Registration Date:	23-Oct-2020.	Application No:	P/07584/011
Officer:	Alistair de Joux	Ward:	Central and Elliman
Applicant:	Stoke Wharf Development LLP	Application Type:	Major
		13 Week Date:	22-January 2021.
Agent:	Savills, 33 Margaret Street, London, W1G 0JD.		
Location:	Land at Stoke Wharf, Stoke Road & Land to west of 9 to 17 Kendal Close &, Former builders merchants to rear and north of 132-144 Stoke Road &, Bowyer Recreation Ground, Slough.		
Proposal:	Comprehensive redevelopment to provide 312 residential units, 329 sq.m. commercial floor space, canal side recreational facilities and public realm improvements, including enhanced recreational facilities within the retained open space at Bowyer Playing field.

Recommendation: Delegate to Planning Manager for Approval

1.0 **SUMMARY OF RECOMMENDATION**

Figure 2: Location of proposed buildings within the site

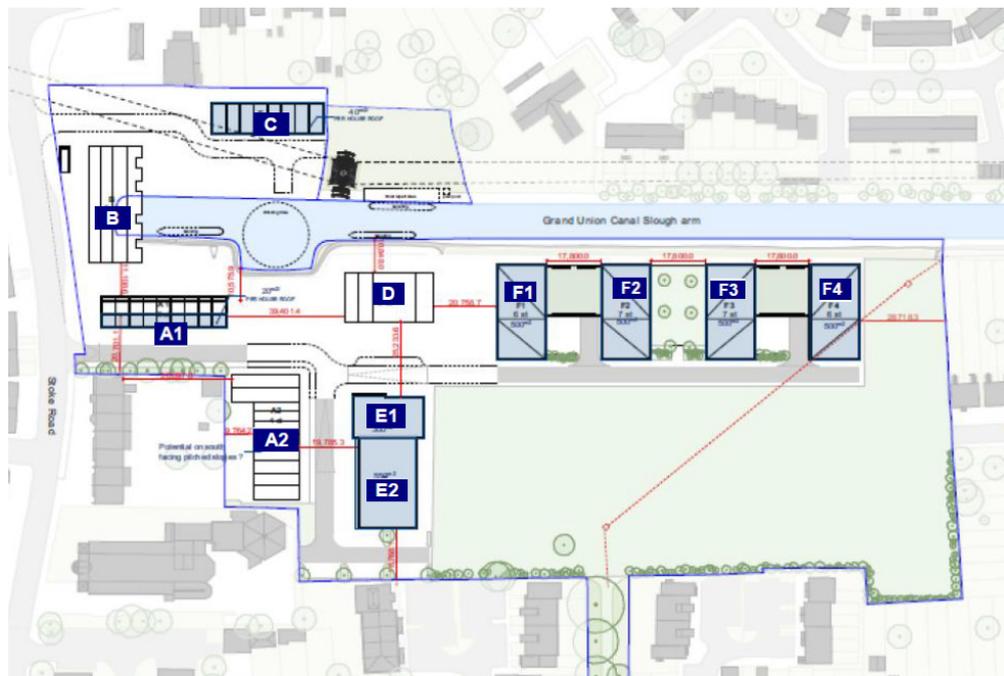
3. Block A1 and relationship with approach to the development from Stoke Road;
4. Block A2 , with particular reference to impacts on neighbours;
5. Microclimate.

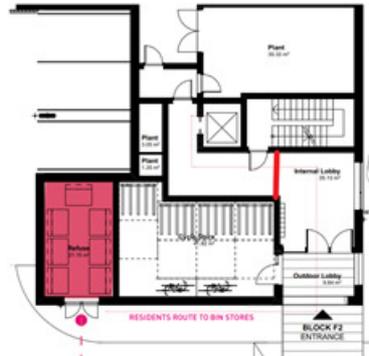
Comments.

Secure residential lobbies for all residential blocks:

- I ask that the design be amended to create and include a secure airlock lobby system (see additional red line below) separating the postal lobby from the private residential core access. Amended plans should be submitted and approved prior to planning application being approved
